Greenhouse Gas Emissions and Fuel Efficiency Standards for Medium- and Heavy-Duty Engines and Vehicles - Phase 2

Response to Comments for Joint Rulemaking

Office of Transportation and Air Quality
U.S. Environmental Protection Agency

National Highway Traffic Safety Administration
U.S. Department of Transportation

Figure 2 Comparison of chassis rolls fuel economy vs Powertrain-in-the-loop fuel economy

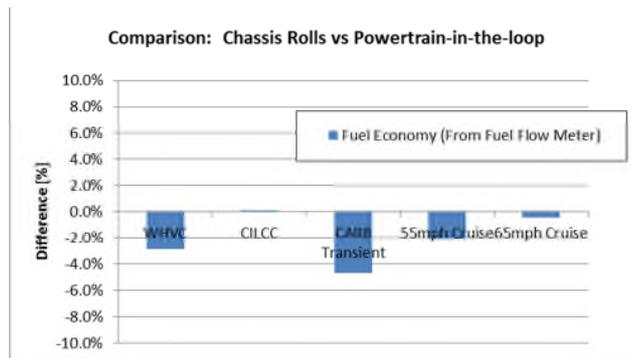
The preliminary results obtained through the powertrain test are uncertain and unproven.

The agencies have modified the powertrain procedure for Phase 2, so that the output of the tests can be used in GEM without A to B testing for a wide range of vehicle configurations. The procedure has been tested and validated with testing at Oakridge National Laboratory (ORNL), Southwest Research Institute (SwRI) and two manufacture laboratories with parent and child ratings of the engine family. This testing has shown that the procedure can be implemented to meet all the requirements of the procedure including the speed regression of the dynamometer. From this testing the agencies have shown that the procedure is repeatable and accurate for measuring the benefits from integrated powertrains. The agencies have also observed that test-to-test variability of measured fuel of the procedure has a coefficient of variation (COV) less than 0.5%, which is at a level seen for engine testing, even though the procedure is testing the transmission with its own variability in addition to the engine. The figure below shows that powertrain testing compares on an absolute basis to chassis testing, but typical COV of chassis testing of heavy-duty vehicles is greater than 2%, due to the additional variability of the driver and the tires.

Figure 3 Comparison of theoretical torque to measured torque

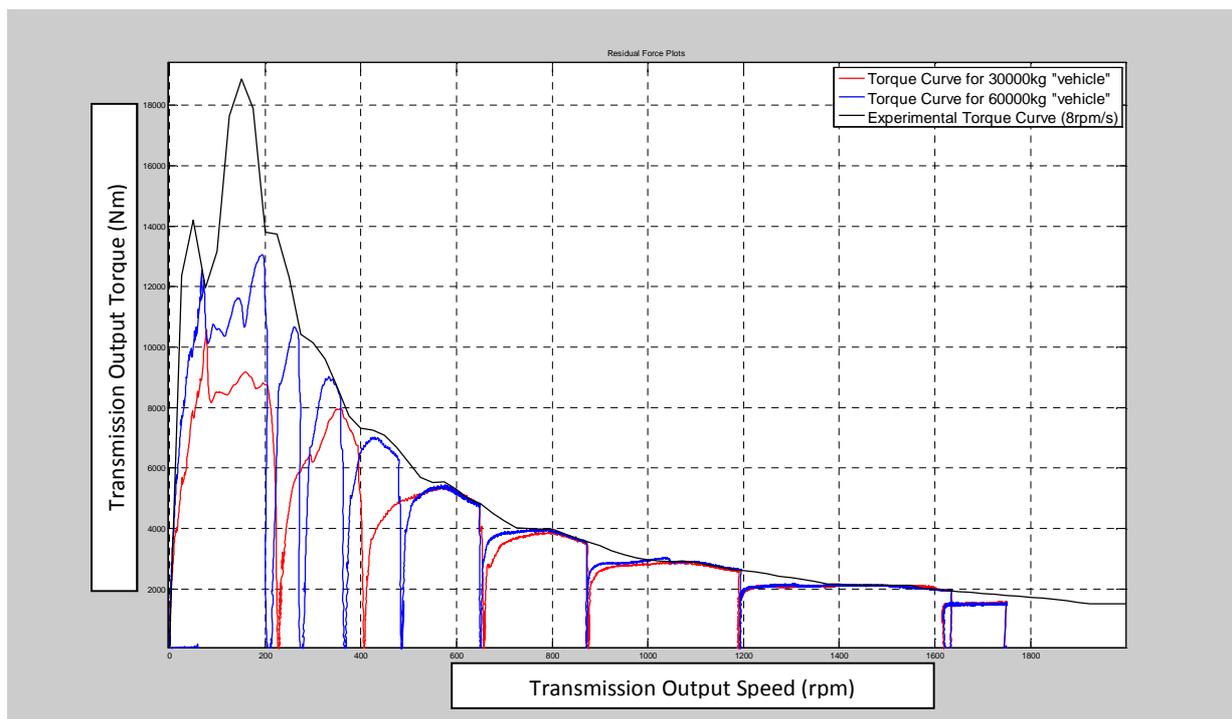
The agencies agree that powertrain testing does add additional requirements over engine testing but our cost analysis outlined in detail in the RIA Chapter 2.9 and RIA Chapter 7.1 shows that for certain highly integrated powertrains the additional complexity and cost is justified by the benefit of being able to show the fuel savings of integrated powertrains and hybrids. As for the comments on high torque in lower gears the agencies have seen that dynamometers that are currently used for heavy-duty engine testing can be used for light-heavy and medium-heavy powertrain testing. Through our work at SwRI we have also shown that with the addition of a relatively inexpensive water brake the typical dynamometer used for heavy-duty engine testing can be adapted to test heavy-duty powertrains.³³ One other thing to note on the torque requirements for powertrain testing is that the powertrain doesn’t stay in lowest gears long enough to produce the theoretical peak torque for those gears. The figure below shows the torque from the Cummins ISX - Eaton USP powertrain where the output speed is changing at different rates. In the first curve in red, the speed is defined by the vehicle model simulating a full throttle acceleration with a 30,000 kg vehicle. Comparing the peak torque of this test to a very slow ramp of 8 rpm/s the powertrain produces just over half the torque. Even when a 60,000 kg vehicle is simulated the peak torque is less than 70% of near theoretical torque of the powertrain in second gear.

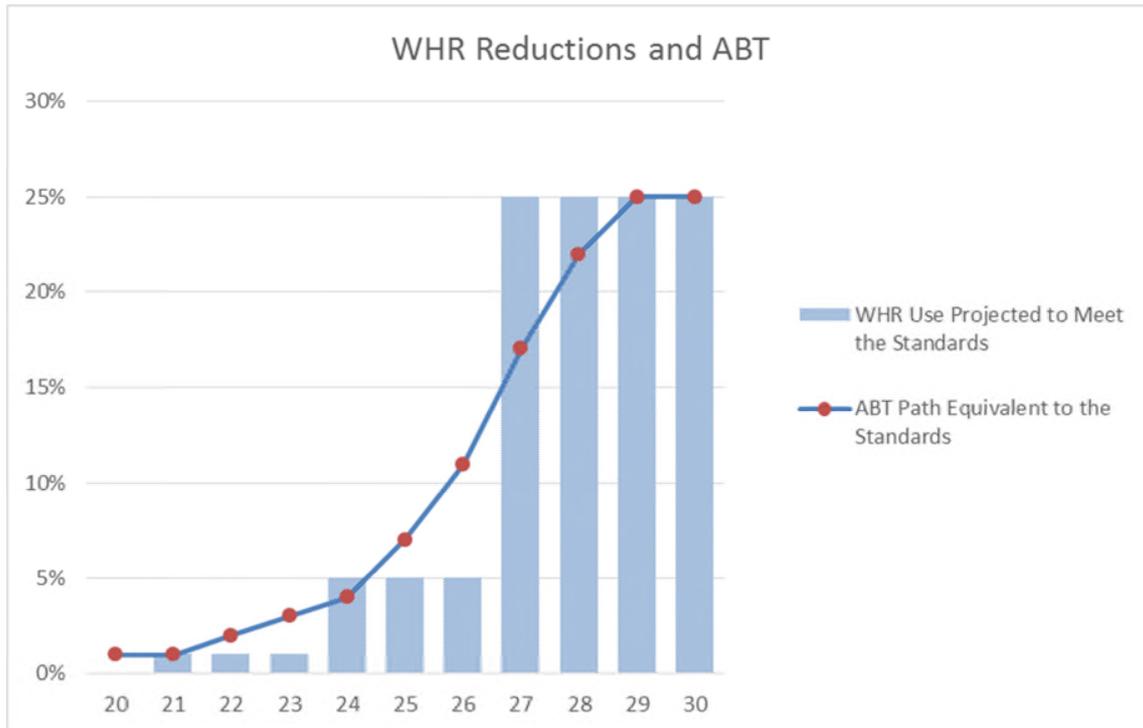
Alternatively, a number of commenters including Cummins, ICCT, CARB, ACEEE, EDF, Honeywell, ARB and others stated that the agencies should increase the assumed application rate of WHR in the final rule and the overall stringency of the engine standards. They argued the agencies' WHR technology assessment was outdated and too conservative, the fuel savings and GHG reduction estimation for WHR were too low, and the agencies' cost estimates were based on older WHR systems where costs were confounded with hybrid component costs and that these have since been improved upon. In addition, the agencies received CBI information supporting the arguments of some of these commenters.

Cummins stated the agencies underestimated the commercial viability of WHR and that we overstated the development challenges and timing in the NPRM. They said WHR can provide a 4 to 5 percent improvement in fuel consumption on tractor drive cycles and that WHR would be commercially viable and available in production as early as 2020 and will exceed the agencies' estimates for market penetration over the period of the rule. According to Cummins, the reliability of their WHR system has

Per-Vehicle Technology Cost Increase for General Motors by Model Year and Alternative (Method A)

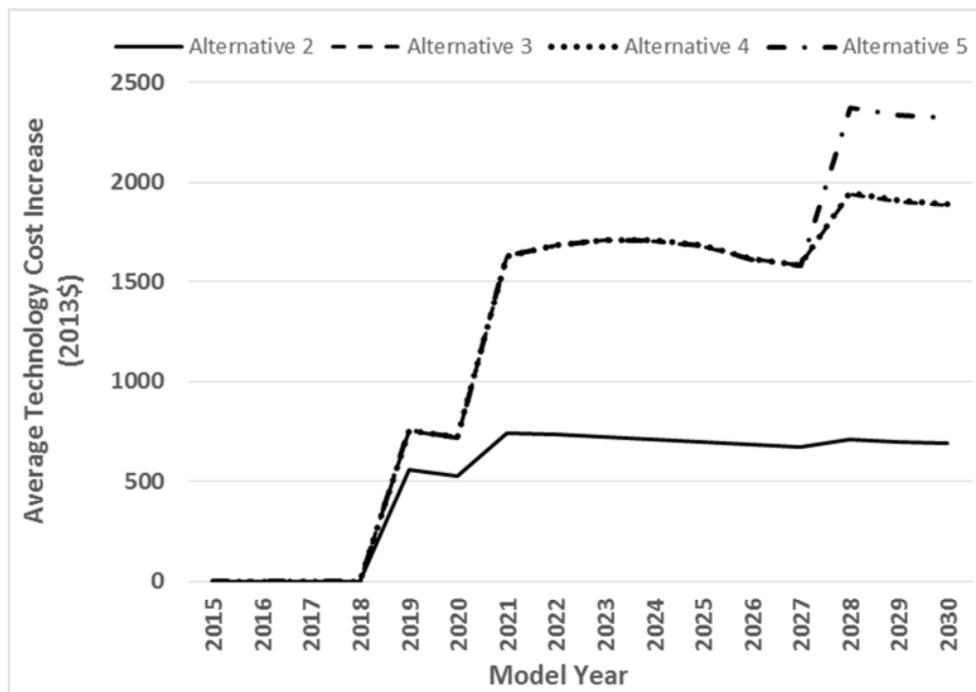
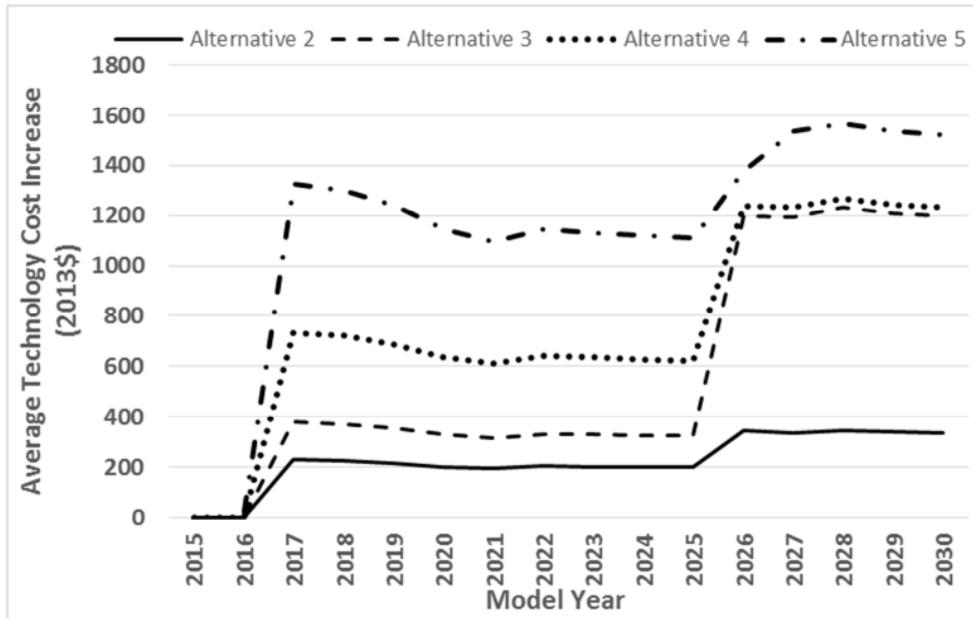
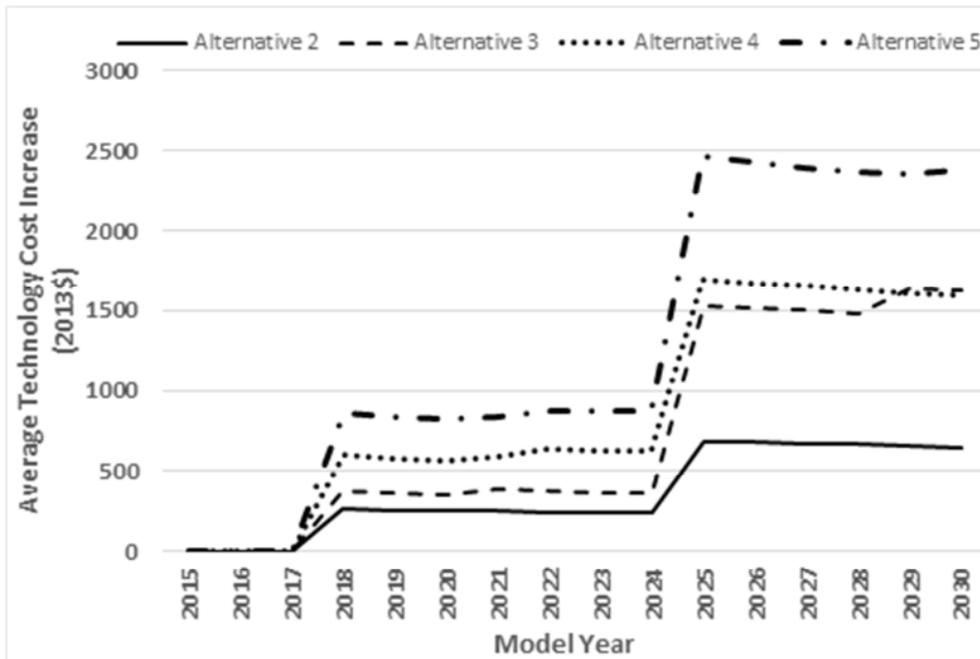
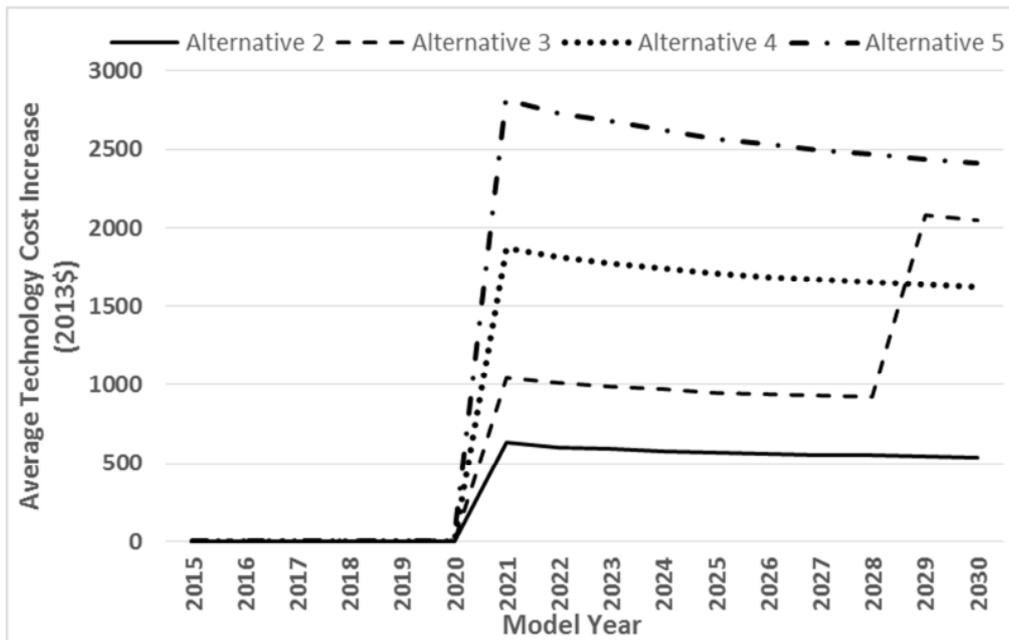
The figures below show the year-by-year average per vehicle technology costs for Method A for GM, Ford, Fiat/Chrysler, and Nissan. The simulated GM progression of technology costs is similar under Alternatives 3 and 4. However: Ford, Fiat/Chrysler, and Nissan show more technology costs in early model years under Alternative 4 rather than Alternative 3. Ford’s simulated compliance strategy shows per-vehicle technology costs of \$400 in MY 2017 under Alternative 3, \$700 under Alternative 4, and almost \$1400 under alternative 5. Alternatives 4 and 5 would put the majority of the cost burden on the

MY 2017 redesign, while Alternative 3 allows most of the cost burden to be on the MY 2025 redesign. The MY 2017 fleet will be in production at the time of publishing this rule. The next major redesign for Ford is not until MY 2025; to add an additional redesign in between the MY 2017 and MY 2025 fleet would involve much capital investment and does not seem feasible.

Similarly, FCA shows technology costs of \$300 in MY 2018 under Alternative 3, \$600 under Alternative 4, and \$800 under Alternative 5. Nissan shows costs of \$1000 in MY 2021 under Alternative 3, \$1800 under Alternative 4, and \$2700 under Alternative 5. The only manufacturer not shown here is Daimler; using the 2015 reference fleet Daimler does not apply additional technology in the regulatory alternatives, and incurs no additional costs. The general sequence of simulated technology costs remains the same as in the NPRM and Method B of the FRM; Alternatives 4 and 5 involve more each incurrence of technology costs than Alternative 3, even though the ending stringency curves for Alternatives 3 and 4 are the same, the additional lead time allows that manufacturers could implement technologies on during later redesigns under Alternative 3. While modeling results show that Alternative 3 could involve some early model year technology costs, they also show that Alternative 2 would forgo much of the benefits of Alternative 3. Further, the results shown here represent only one possible way that manufacturers may meet regulatory alternatives; they may avoid adding technologies in early model years, but adding more to reach over-compliance in later model years. For these reasons, NHTSA has determined that Alternative 3 represents the maximum feasible standards. Further description of the rationale behind the finalization of these standards can be found in Chapter VI.D.(9) of the Preamble and Chapter 10.2.8 of the RIA.

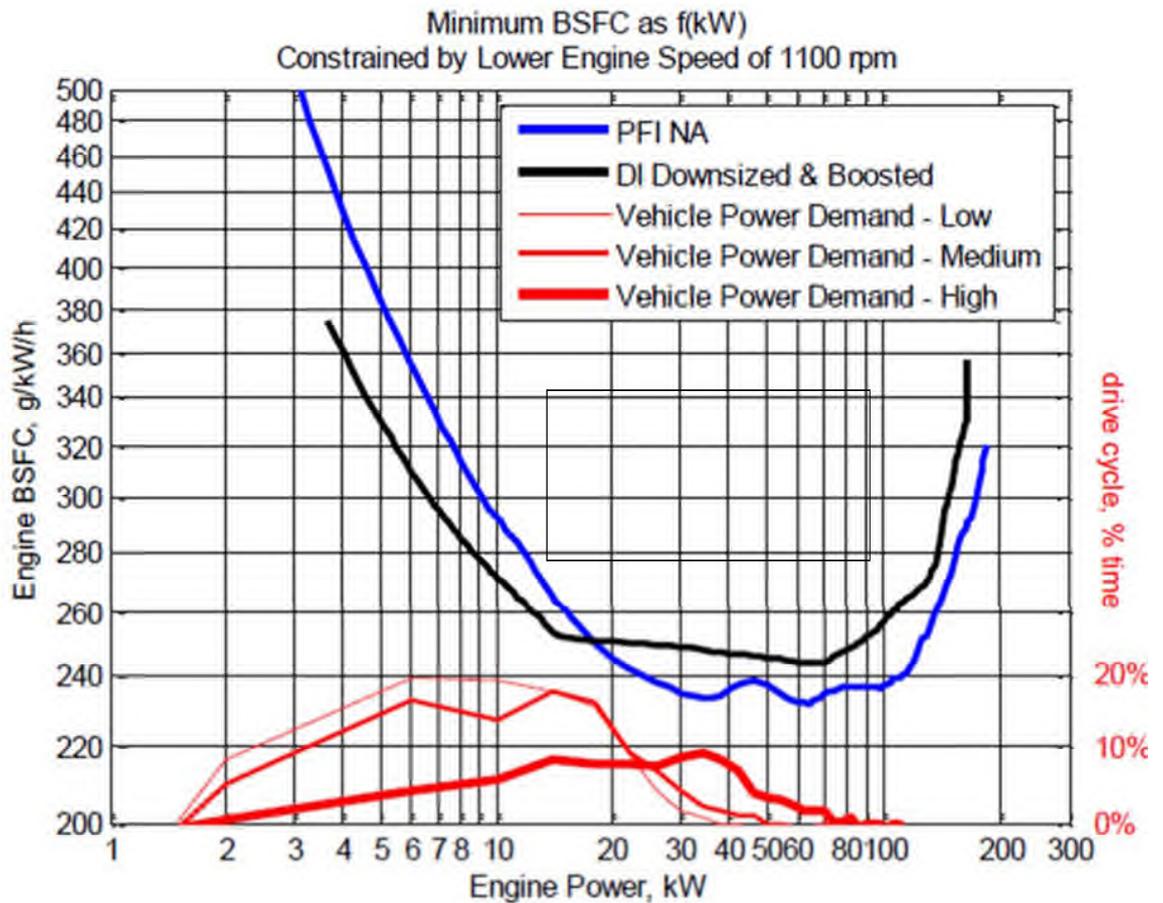
AAPC commented in support of an alternative year-over-year phase-in that would phase-in stringency more gradually than the proposed (and now adopted) standard. AAPC recommended that rather than a 2.5 percent per year improvement, the increase should be at 1.75 percent per year through MY 2024 and then 3.5 percent per year for MY 2025 through 2027 with the MY 2027 level of stringency equally the proposed level. AAPC commented that this more gradual approach was consistent with the Phase 1 phase-in approach and would help manufacturers manage the long lead time associated with developing the new vehicles and powertrains that will be required in order to comply with the Phase 2 proposal.

The agencies are finalizing the proposed phase-in rather than adopting the approach recommended by AAPC. The more gradual phase-in recommended by AAPC would result in a loss of program benefits in each of the interim years of the program compared to the promulgated standards until the phase-in caught up with that phase-in in MY 2027. Because of the slower phase-in, the overall reduction in each interim year is lower than the phase-in being finalized. The phase-in adopted for Phase 1 with a more gradual ramp-up in standards took into consideration the shorter lead time associated with the Phase 1 standards and the uncertainty associated with implementing a new program. Phase 2 provides more lead-time than Phase 1 and the agencies believe based on their analyses of the standards that the lead-time provided is sufficient, particularly considering the flexibility also provided by credit carry-forward and carry-back provisions.
